Request for clarifications on Supplement C – 0101

Received from a specific group on July 16, 2001

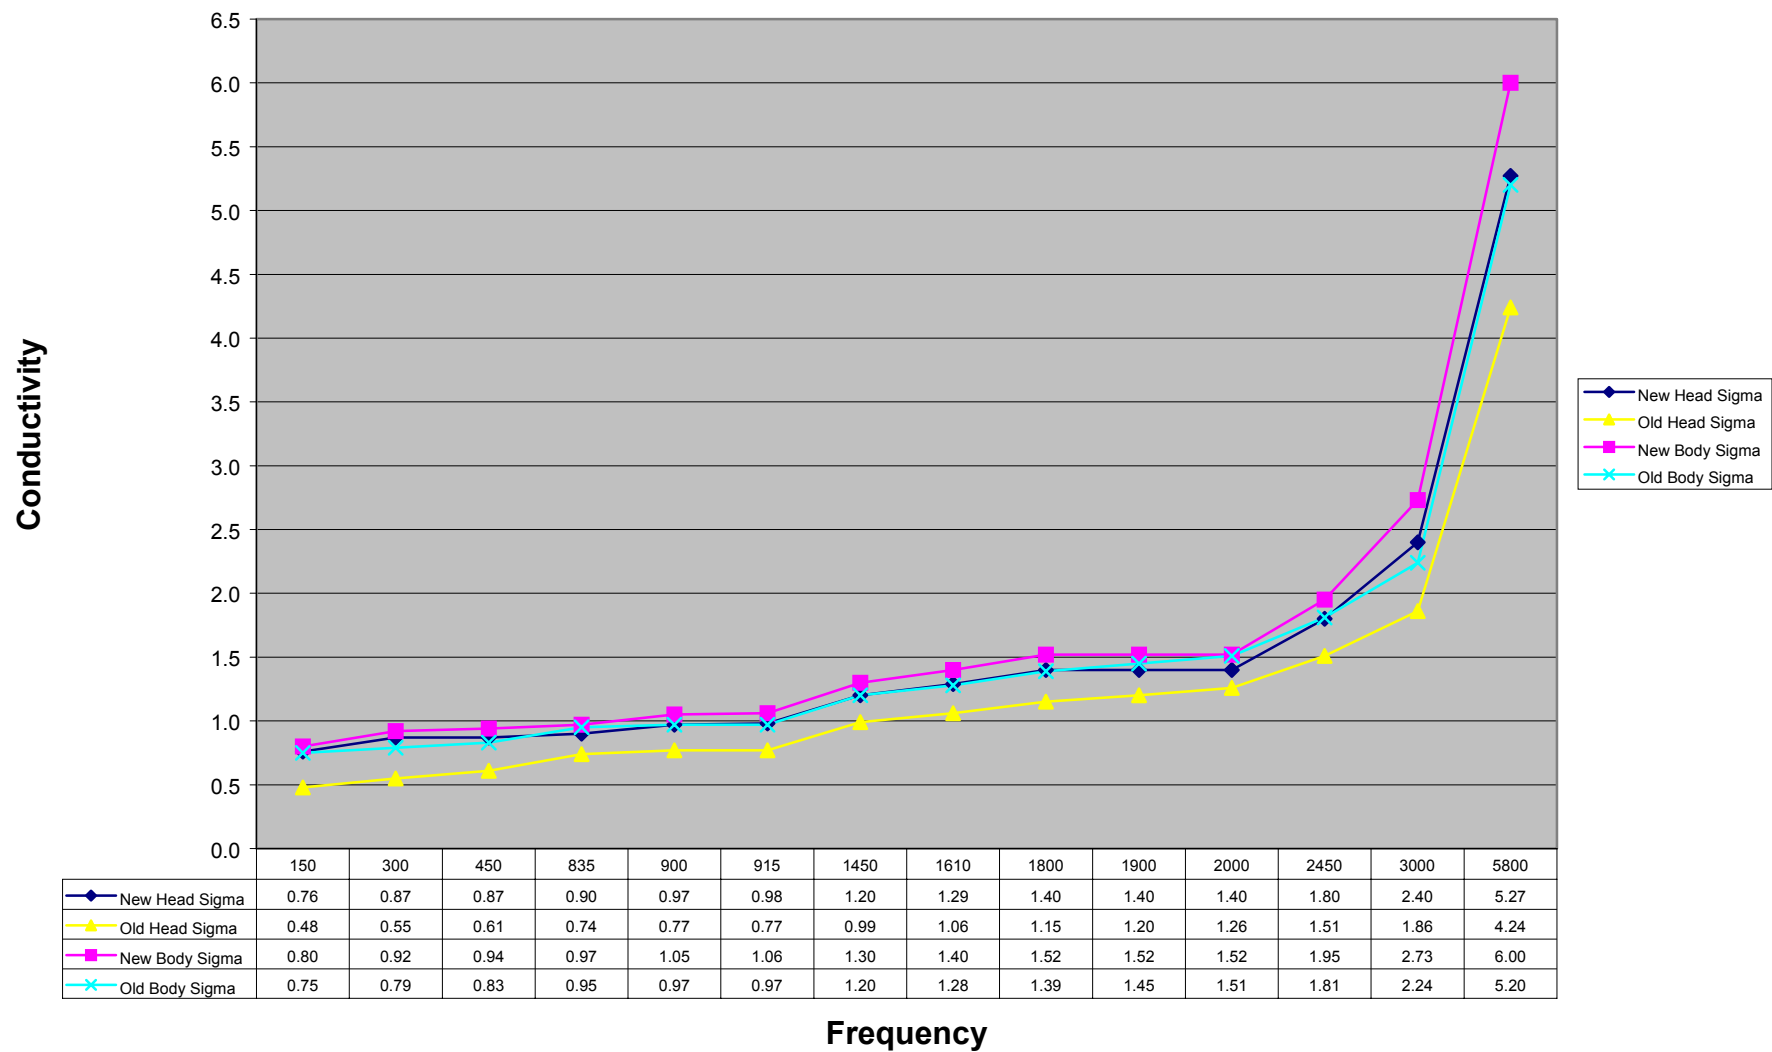
23. On page 47, step 9 of the System Verification: We suggest the sentence “The SAR distribution must be identical to the reference data” be changed to read “The SAR distribution should be similar to the reference data”. The reason is that “identical” is a very exacting word and could be interpreted to require a rigorous mathematical comparison of the two plots, which is not, we believe, the intent.

There is no reason for the SAR distribution of a dipole source that meets the specifications in Supplement C to show visually discernible differences from its

reference data. “Identical” means no visually discernible differences in the SAR distribution plots. We have seen SAR distributions submitted in equipment approval filings that are distorted due to improper positioning procedures. Although the 1-g SAR values may still be within 10% of the target values, the results are invalid when the dipole is improperly positioned.
